Access Compliance Report Public Rights-of-Way (Curb Ramps)

Intersection ID: 27505 Main Street: WATERSREACH LN **Cross Street: WOODRIVER_LN** Location: ADA ID: 59BA4B0B9A92 Ramp Type: PerpDiag Initial Pass/Fail: Fail **Overall Compliance: No Severity Score:** 22.5

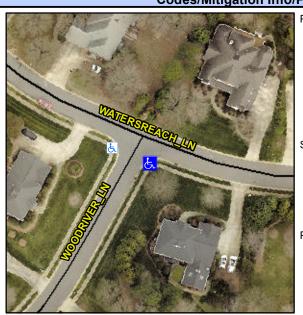
Possible Solutions: Remove & Replace Curb Ramp With Two New Directional Ramps or Equivalent. Surveyor Notes: N/A PROW/ADA: Not Found, R304.5.1, R304.2.2, R304.5.3

| Field Measurements/Component Compliance | | | | | |
|---|-----------------------|-------|------|-----------------------------|-------|
| N/A | Ramp Length (in) | 95.0 | No | Ramp Slope (%) | 9.3 |
| No | Ramp Width (in) | 45.0 | No | Ramp XSlope (%) | 4.1 |
